Subject: **Request for Modification of Section 404 General Permit No. 198200031 and Section 401 Water Quality Certification, and lifting of Notice of Violation Status** for the Interstate 85 (I-85) widening and interchange improvements from north of NC 73 to north of SR 1280, Cabarrus and Rowan Counties, Divisions 9 and 10. Federal Aid Project No. NHIMF-085-2(61)55, TIP I-3802A.

The North Carolina Department of Transportation (NCDOT) requests modification to the existing General Permit No. 198200031 and associated Water Quality Certification for widening and interchange improvements along I-85 in Cabarrus and Rowan Counties. This project is currently under construction.

Revisions have been made to seventeen impact sites and are discussed in detail below. Two new impact sites are also discussed below (Site 36 and the Troutman waste site).

PROJECT REFERENCE NO. <b>L-3802A</b>	SHEET NO. <b>15A</b>
RW SHEET NO. ROADWAY DESIGN ENGINEER	HYDRAULICS ENGINEER
<b>BLYTHE</b>

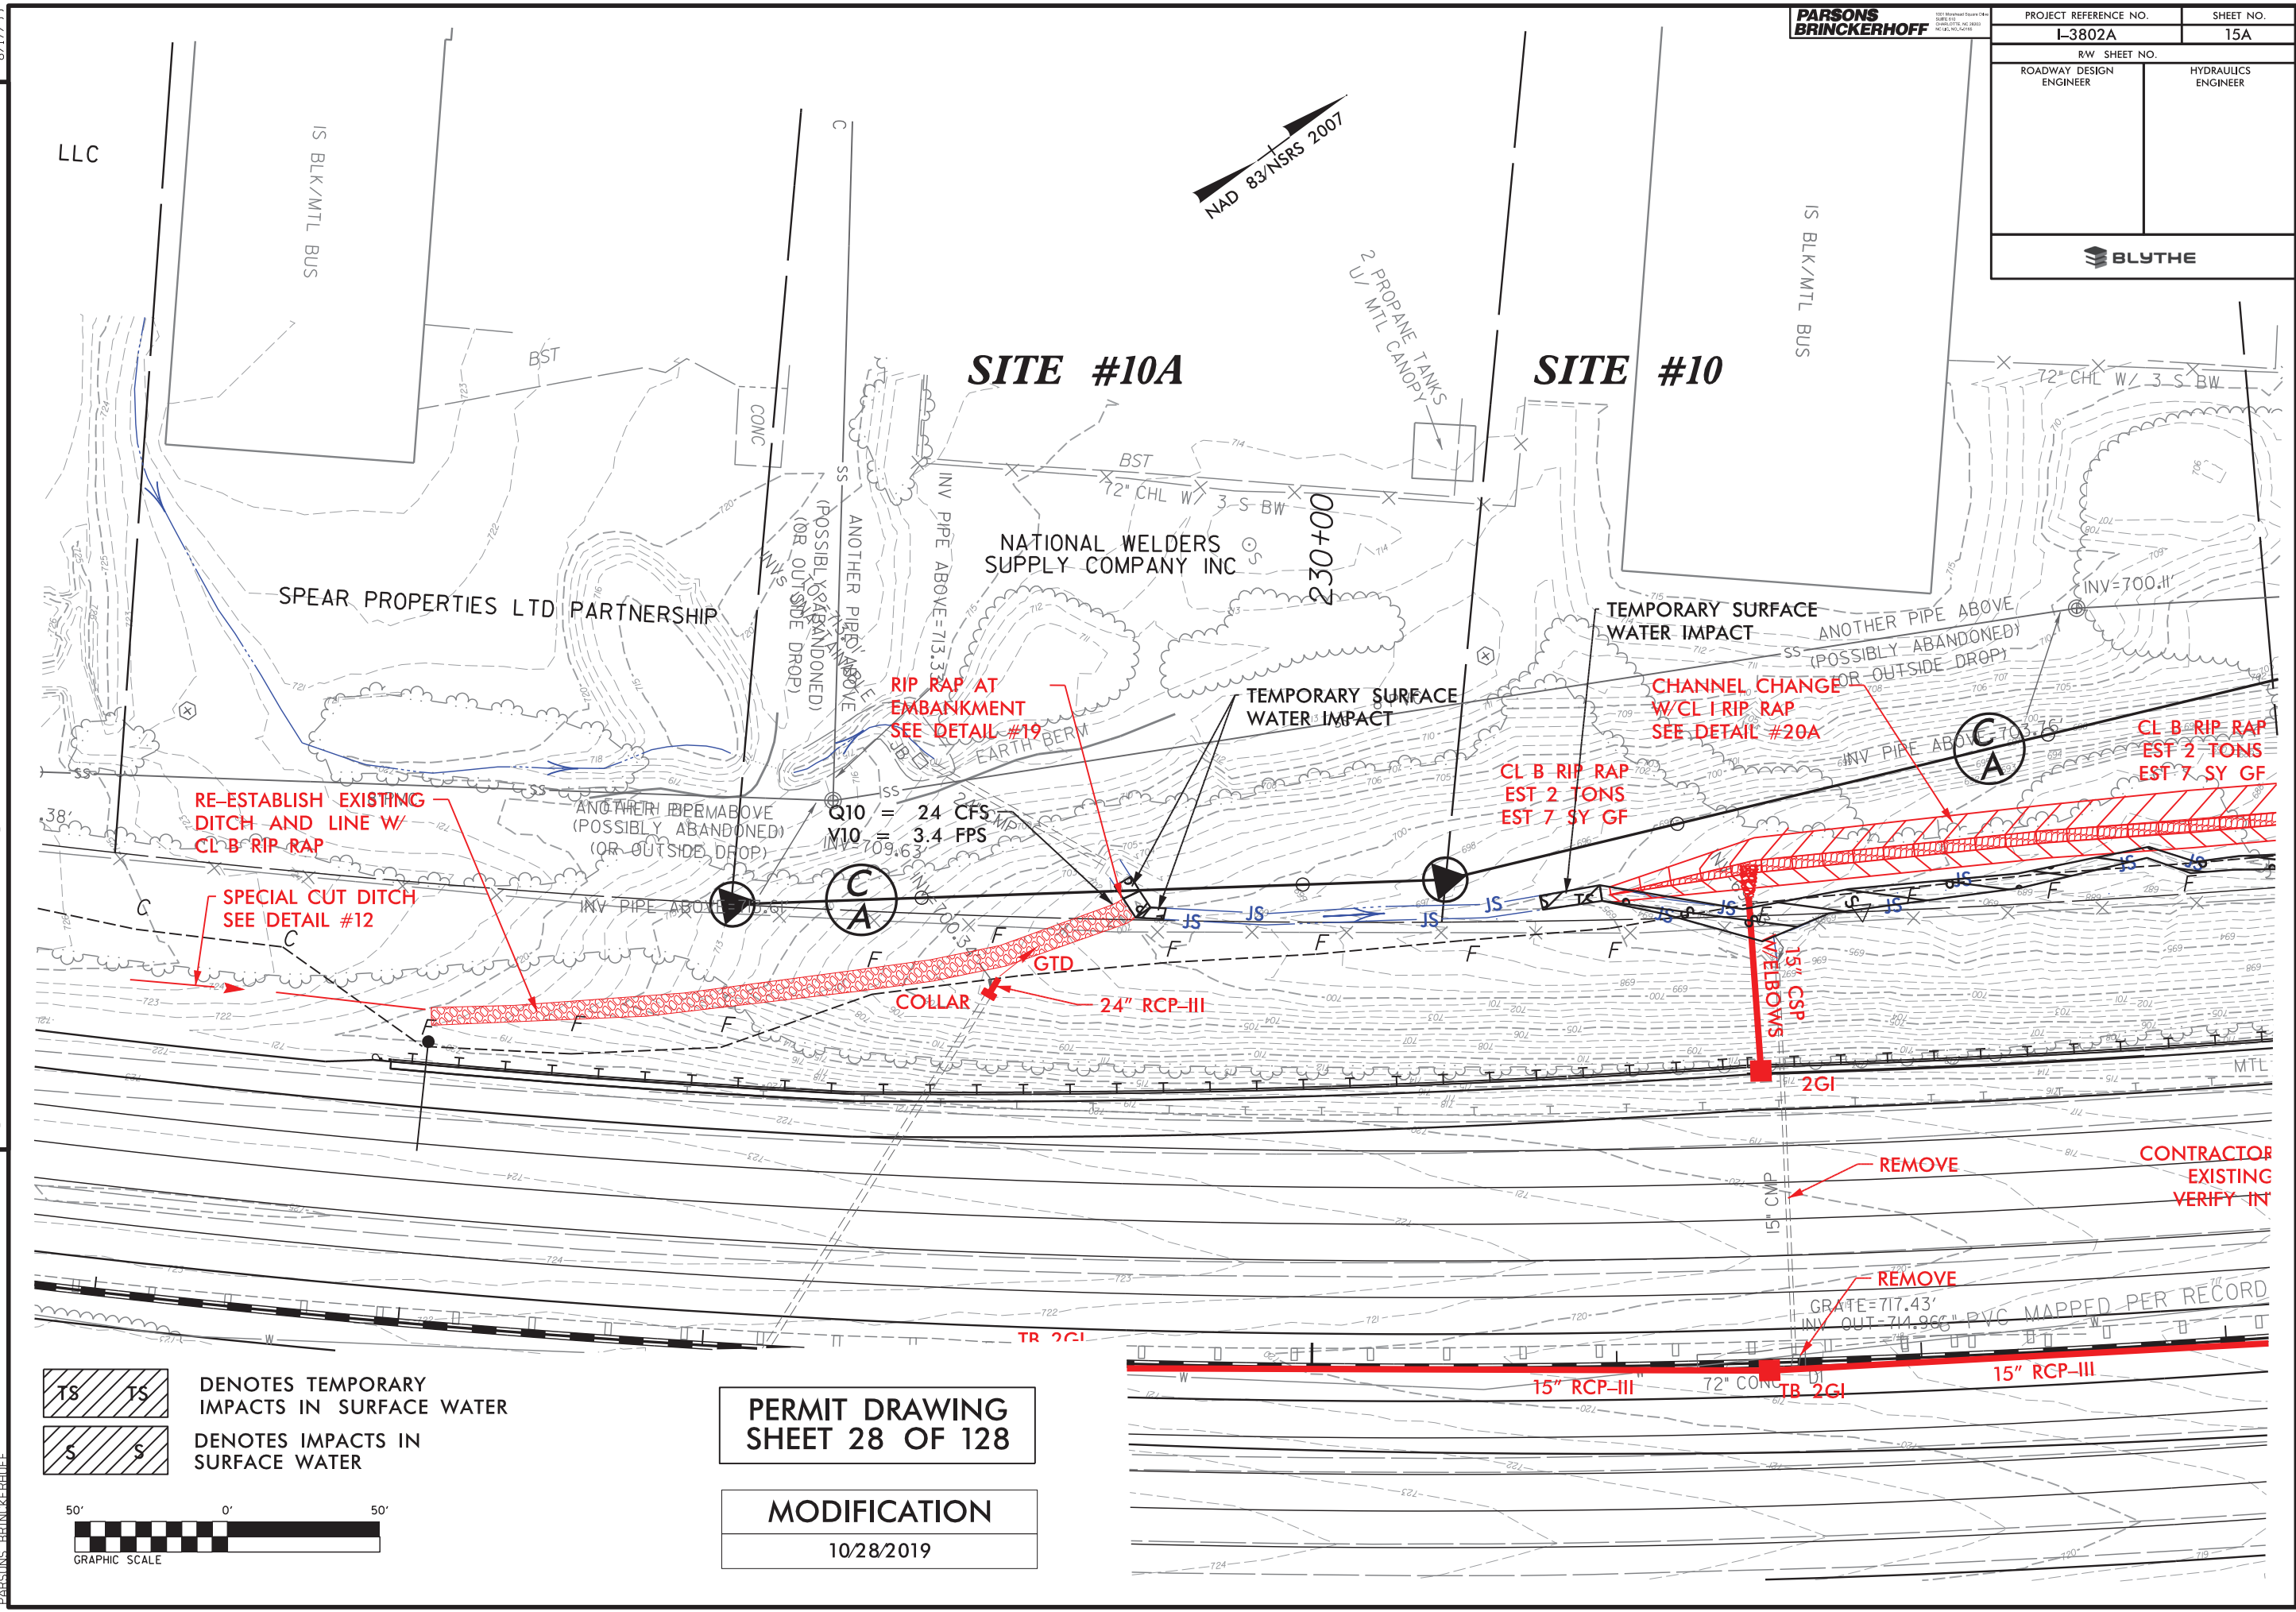
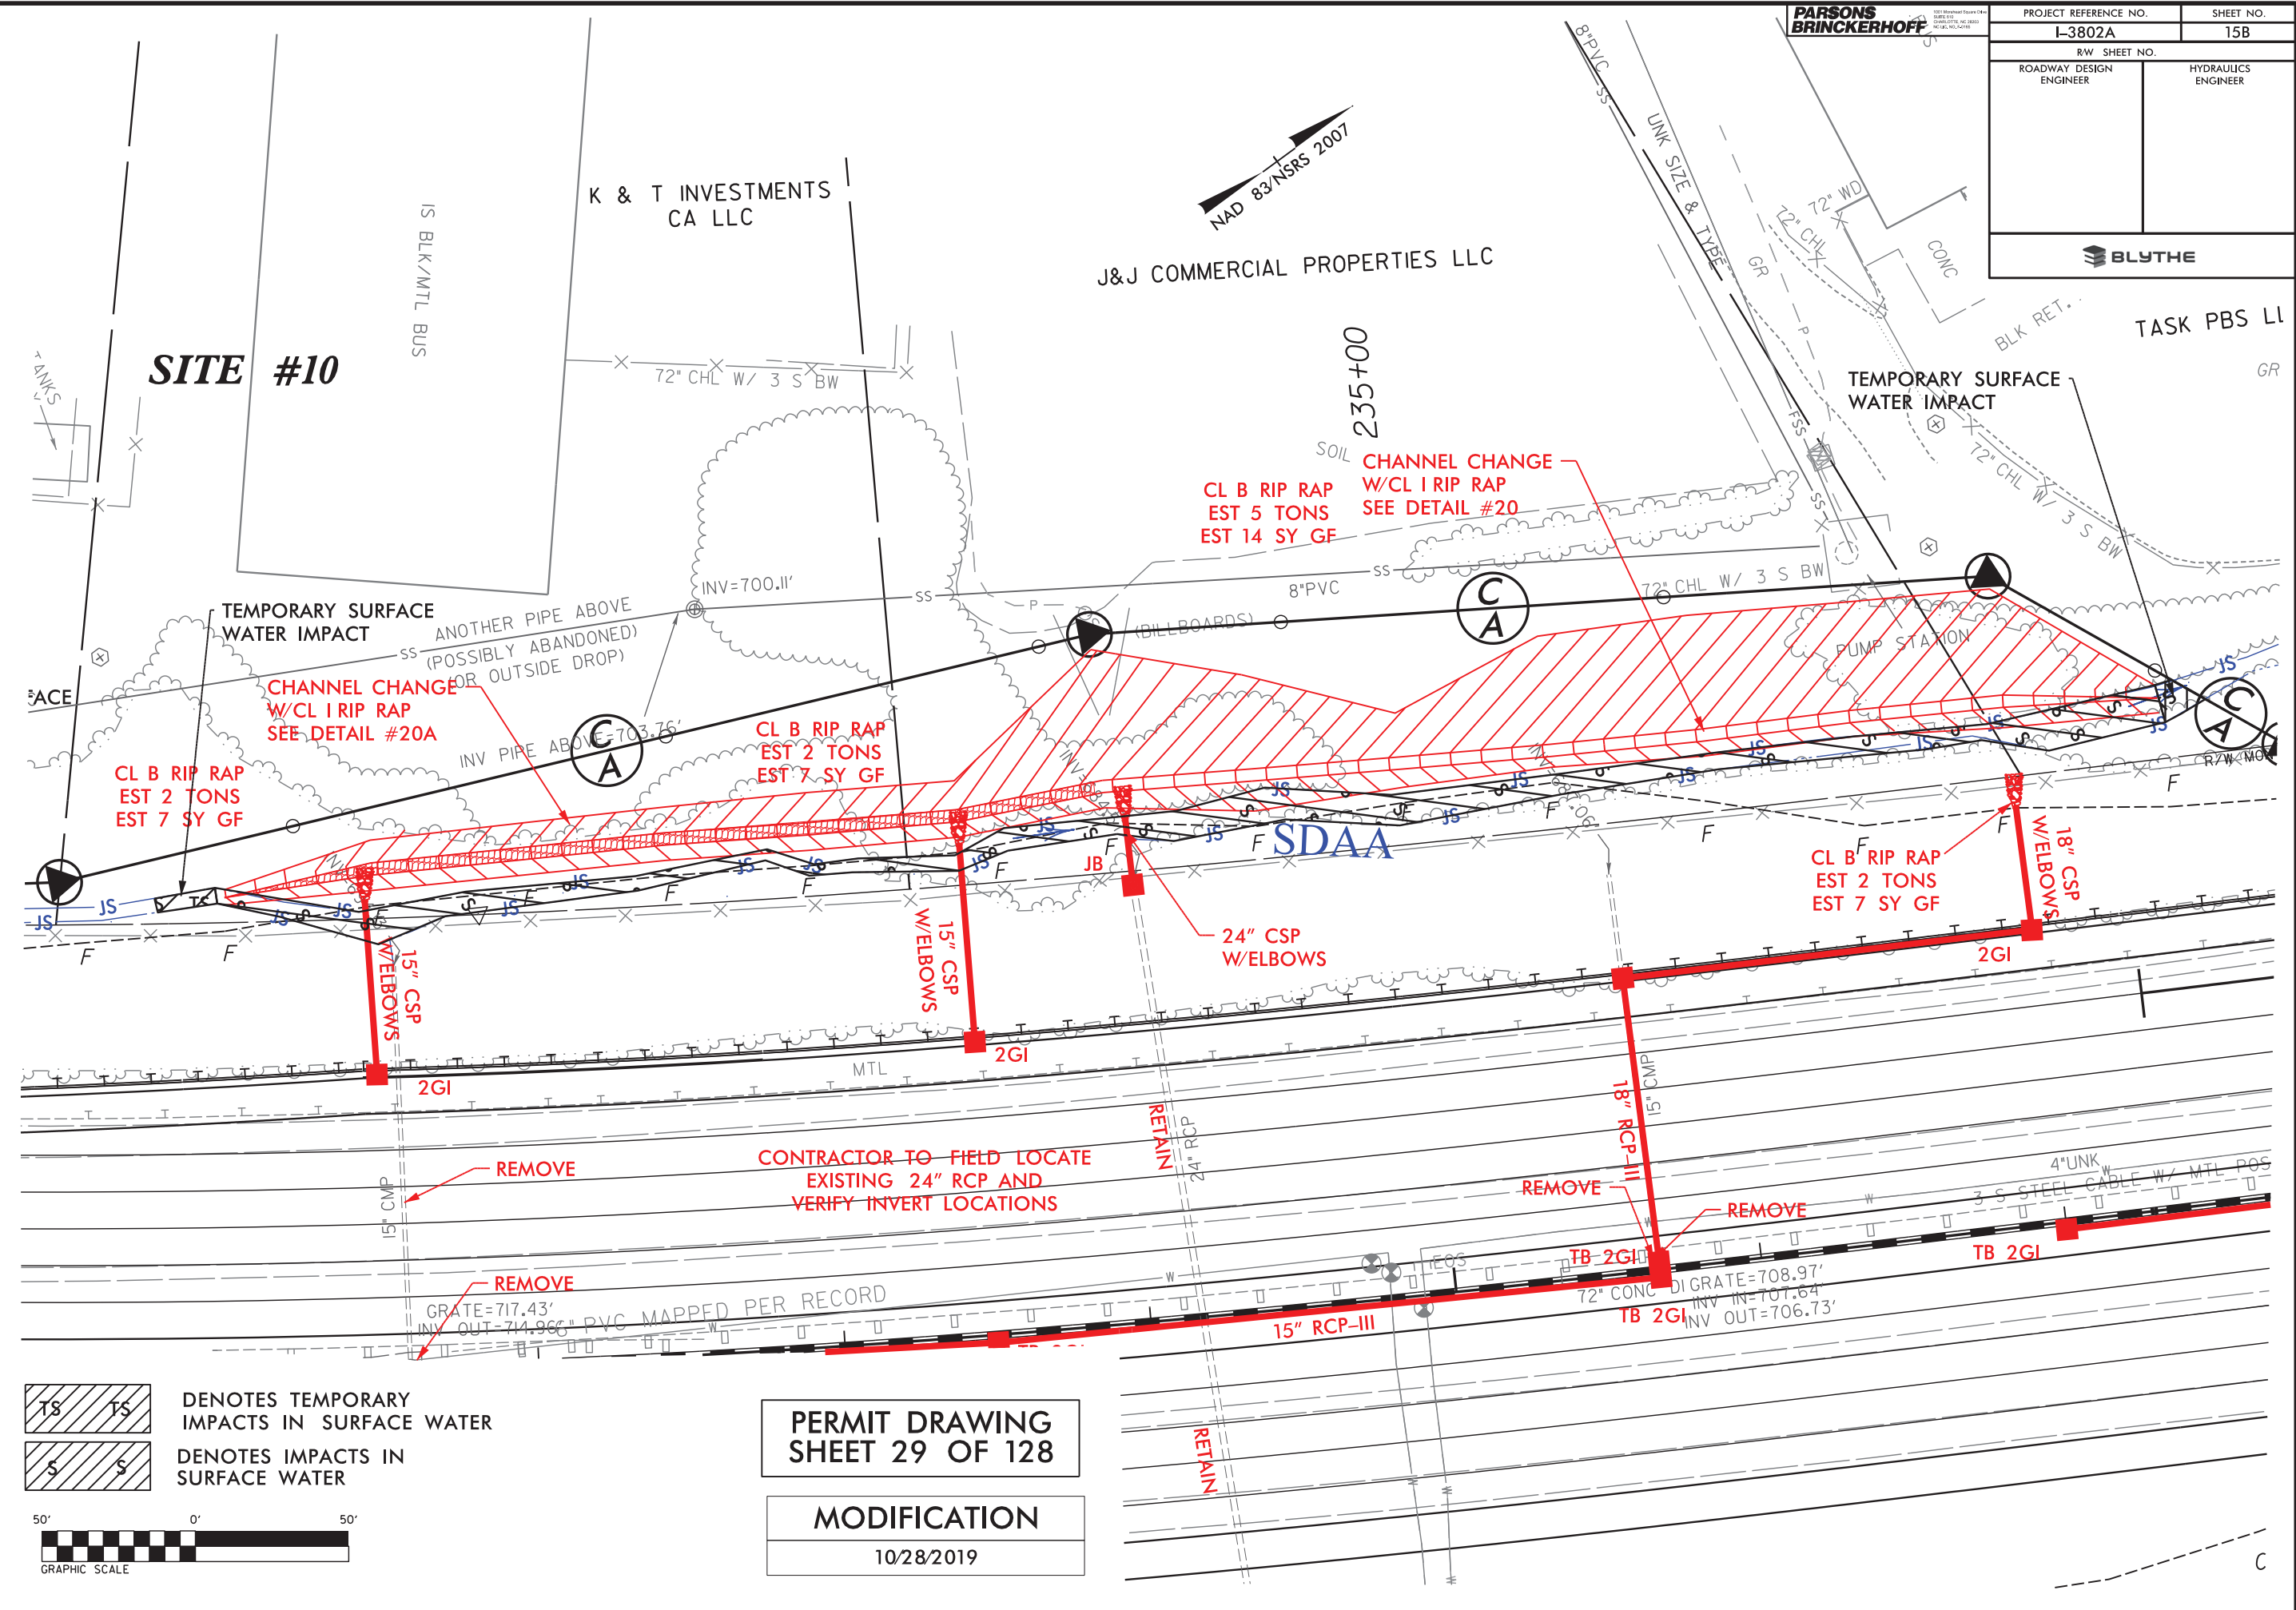
Site 10 (Sheet 15) – The permitted drainage design included a channel change with rip rap only on the banks for stream SDAA. Class I rip rap was installed in the bottom of the channel change for 300 linear feet to provide additional stabilization to address stability concerns. Also, the channel change was shortened by 20 linear feet to make a smoother transition to existing stream channel. Permanent stream impacts were reduced from 666 linear feet to 646 linear feet, which is 20 linear feet of less impacts.
